## **Porcupine Caribou Management Board Submission to YESAB**

### **YESAB file 2014-0112: Eagle Plains Multi-Well Exploration Program by Northern Cross Yukon: Follow-up review of potential impacts and mitigations with respect to the Porcupine Caribou Herd**

**December 15, 2015**

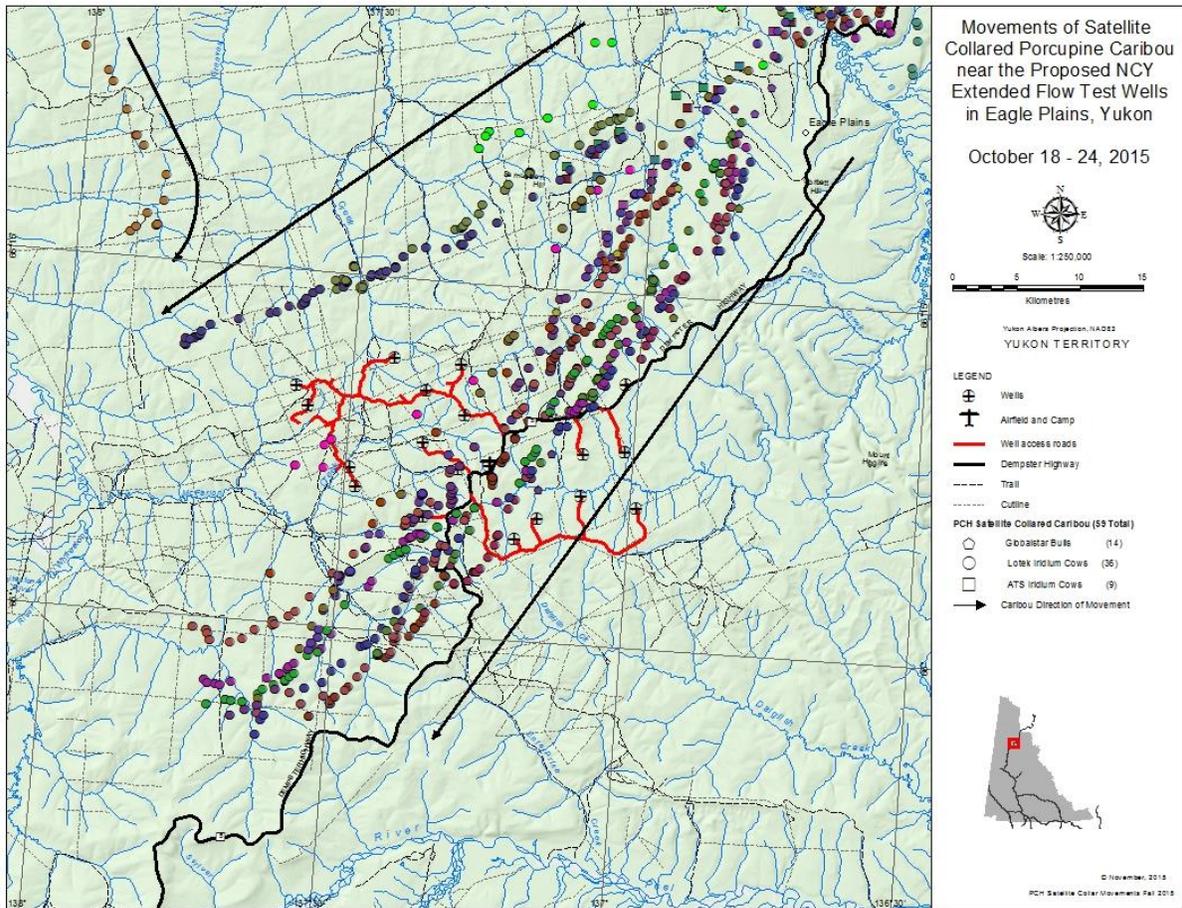
Detailed data from this year allows us to demonstrate caribou movements more definitively than previously because of the high resolution of data available today (i.e. weekly as compared to every day). Movements in November of this year likely represented 50,000+ caribou migrating directly through the project area with many tens of thousands immediately adjacent, for a total of >100,000 caribou. Once the bulk of caribou moved through the area (Figures 1-2), many turned around and moved back north through and into the project area again (Figures 3-4). Large segments have moved back into this same area and we anticipate large numbers in the general region (Figure 8). Currently, PCH are wintering throughout the general area, including in the specific project area. Movements this year typify what can be expected in the future, although it is impossible to anticipate the frequency which could range from many consecutive years to more sporadic occupation of the area. It is clear that we can anticipate a wide range of use of the project area from tens of thousands to small or no groups of caribou in a given year, and the period may vary from days to all winter. Therefore, detection of groups in the project area prior to new activities is key to successful mitigation (Figure 6-7).

Figure 1 – The Porcupine caribou herd migrated SW following ridge features (including the Dempster Highway) between October 18 and 24. Although it is impossible to determine the exact numbers of caribou involved in this movement, based on the proportion of collars involved, at least 50,000 caribou moved through the project area. Closer to 100,000 caribou were likely in the area.

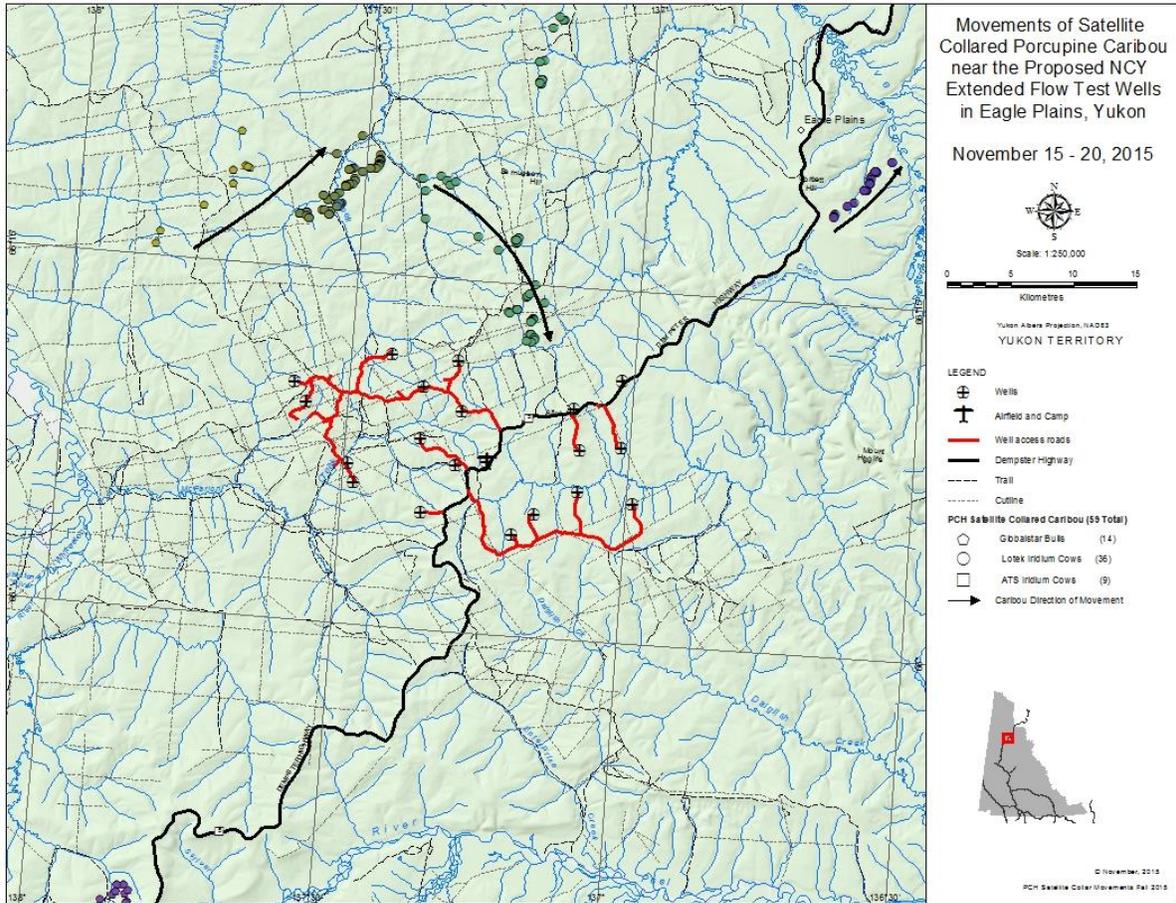
Figure 5 – Wintering caribou continued to move around, including local movements in the immediate vicinity of the project. At this time of year, groups of caribou are generally more scattered and there is a greater likelihood that groups without collars would be detected using aerial surveillance. Ground surveillance would also detect caribou although far less efficiently and with a much greater likelihood of missing groups. (See note on page 5)

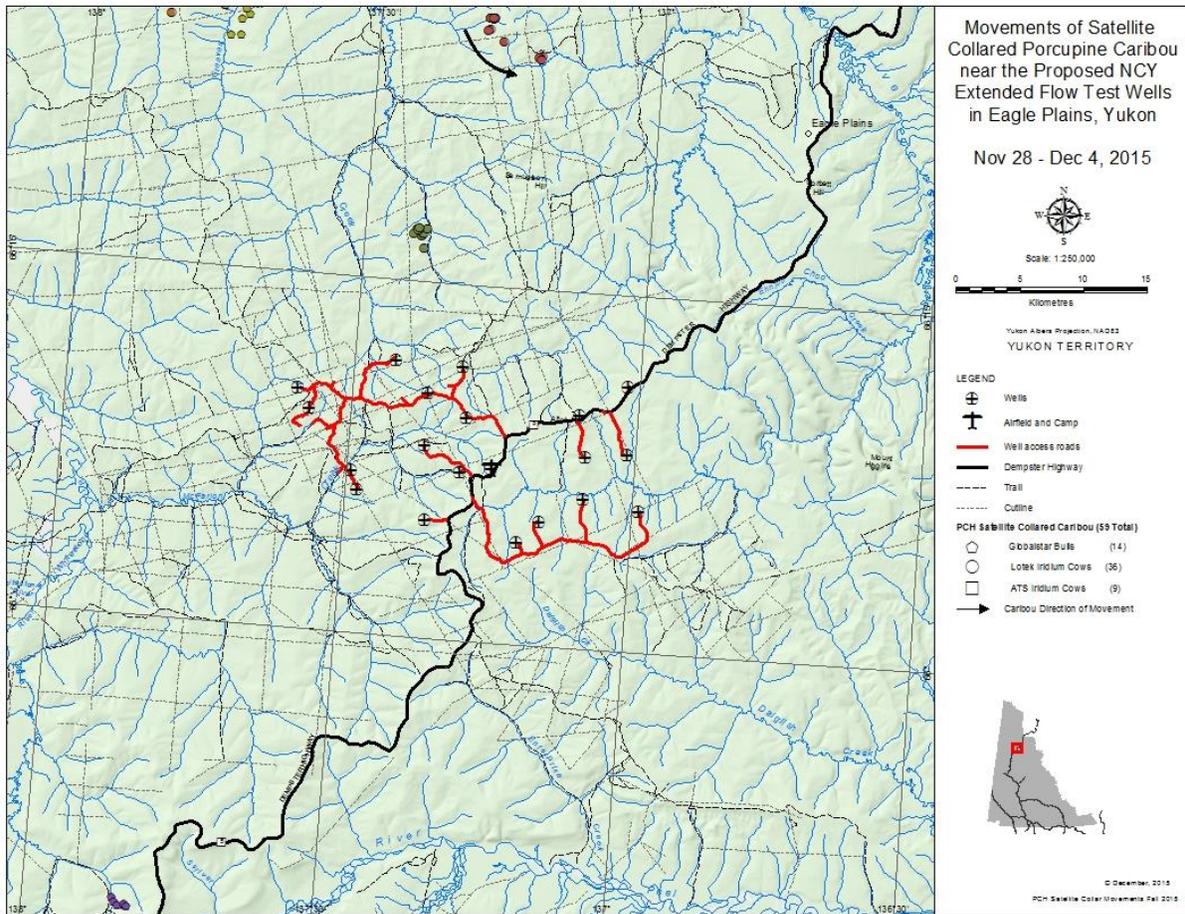
Figure 7 – One collar remains near the project area. It is extremely likely that many groups of caribou remain scattered through the area. For this reason the use of collars alone is insufficient. Collars may tell you where caribou are, but cannot tell you where caribou are not. Both visual and collar data is required to make this determination. (See note on page 5)

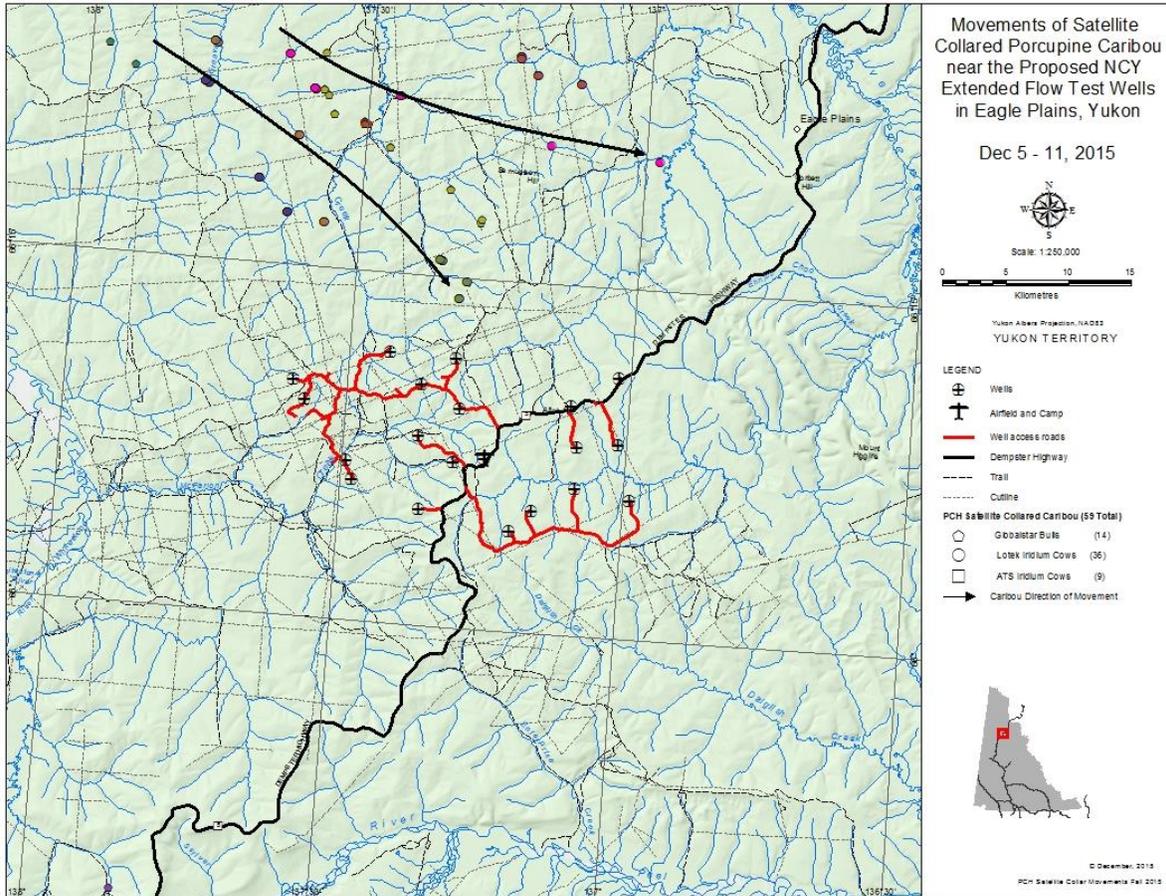
Figure 8 – Although not extremely evident from this figure, large numbers of caribou have again moved into and adjacent to the project area. This figure likely represents many thousands of caribou moving into the project area in addition to those already wintering there. Some areas within the project that are not burned contain very high-quality lichens. Even within burns, local areas such as riparian areas often are not burned and can hold caribou for long periods, as was noted east of the Dempster Highway in spring of 2014 when NCY’s 3D seismic program was operating.
